Access Compliance Report

Public Rights-of-Way

Intersection ID: 31296	Main Street: DEERTON_RD	Cross Street: MELSTRAND_WY	Location: E
ADA ID: 2A1BF1CC3E9D	Ramp Type: PerpDiag	Initial Pass/Fail: Fail	Overall Compliance: No
			Severity Score: 33.75

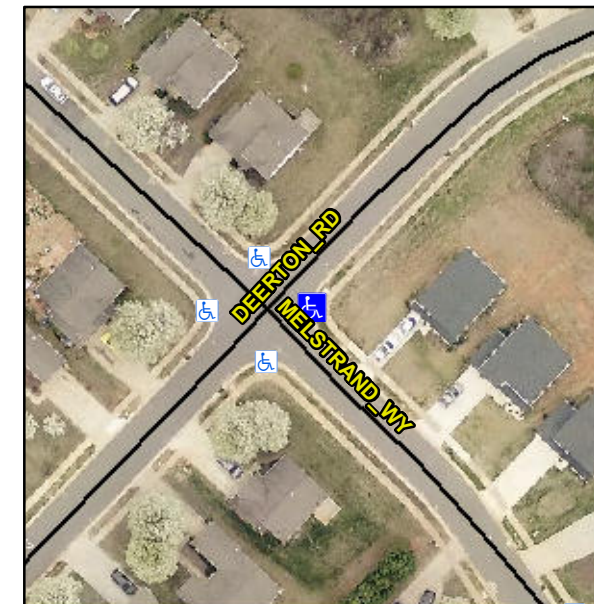
R304.5.1, R304.5.3

Compliance	Description	Data	Compliance	Description	Data
N/A	Ramp Length (in)	48.5	Yes	Ramp Slope (%)	7.2
No	Ramp Width (in)	45.0	No	Ramp XSlope (%)	7.3
N/A	Flare Type LT	N/A	N/A	Flare Type RT	N/A
N/A	Flare Slope LT (%)	N/A	N/A	Flare Slope RT (%)	N/A
N/A	Flare Traversable LT?	N/A	N/A	Flare Traversable RT?	N/A
N/A	Landing Length (in)	N/A	N/A	DWS Provided?	N/A
N/A	Landing Width (in)	N/A	N/A	DWS Contrast?	N/A
N/A	Landing Slope (%)	N/A	N/A	DWS Length (in)	N/A
N/A	Landing X Slope (%)	N/A	N/A	DWS Full Width?	N/A
N/A	Landing Curb? (Y/N)	N/A	N/A	DWS Offset (in)	N/A
N/A	Shared Landing?	N/A			
N/A	Gutter Ponding?	N/A	N/A	Gutter Slope (%)	N/A
N/A	Gutter Lip Ht (in)	N/A	N/A	Gutter X Slope (%)	N/A
N/A	Painted X Walk1?	No	N/A	Painted X Walk2?	No
	X Walk 1 Direction	To NW		X Walk 2 Direction	To SW
N/A	X Walk 1 Width (in)	N/A	N/A	X Walk 2 Width (in)	N/A
	X Walk 1 Slope (%)	2.7		X Walk 2 Slope (%)	7.5
	X Walk 1 X Slope (%)	7.6		X Walk 2 X Slope (%)	1.8

Remove & Replace Curb Ramp With Two New Directional Ramps or Equivalent.
